Backfeed v260

v260 Removed the 3-pair backfeed requirement altogether, and replaced it by a change to the detection requirement, that now includes 2-pair, 3-pair, and 3-pair + pullup.

Figure 145–27a—Detection signature requirements connection configurations

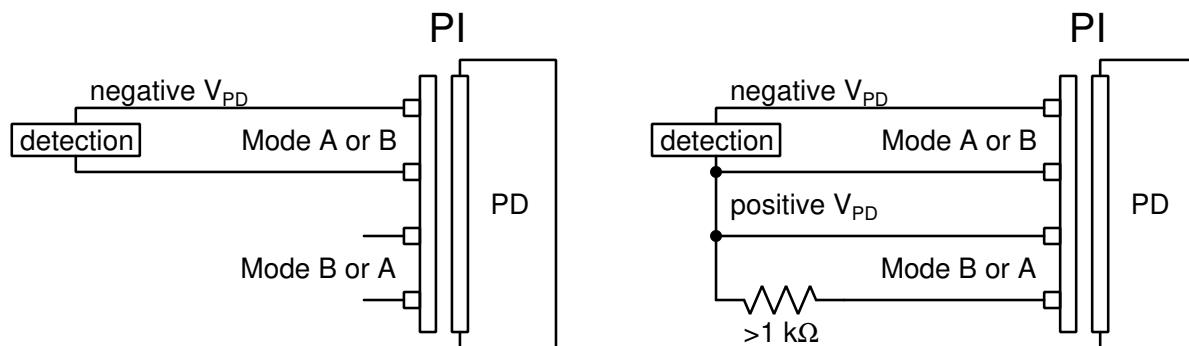
When a PD presents a valid or non-valid detection signature, it shall present the detection signature on each pairset, when probed per any of the valid 2-pair configurations defined in Table 145–20, with the additional requirement that one pair denoted with “—”, indicating that it is not connected to a supply rail, is connected to positive V_{PD} with any series resistance greater than $1\text{ k}\Omega$ (see Figure 145–27a).

Figure 145–29a — Reflected voltage requirements

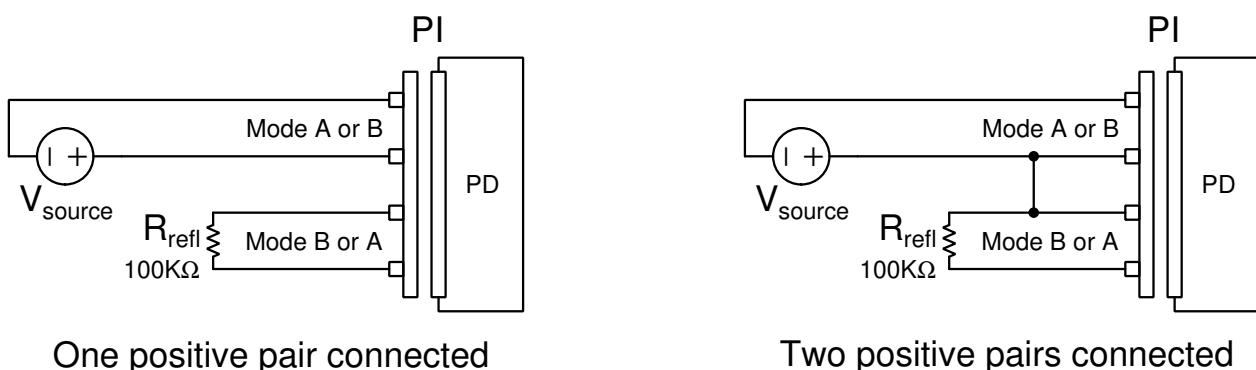
For a single-signature PD, when any voltage in the range of 0 V to $V_{Port_PD-2P \ max}$ is applied per any of the valid 2-pair configurations, defined in Table 145–20, that have only a single pair connected to positive V_{PSE} (see Figure 145–29a), the voltage on the Mode not connected to the voltage source, with a 100 k Ω resistor connected across that Mode, shall not exceed V_{refl} as defined in Table 145–29.

For a dual-signature PD, when any voltage in the range of 0 V to $V_{Port_PD-2P \ max}$ is applied per any of the valid 2-pair configurations, defined in Table 145–20, including those with two pairs connected to positive V_{PSE} (see Figure 145–29a), the voltage on the Mode with at least one pair not connected to the voltage source, with a 100 k Ω resistor connected across that Mode, shall not exceed V_{refl} as defined in Table 145–29.
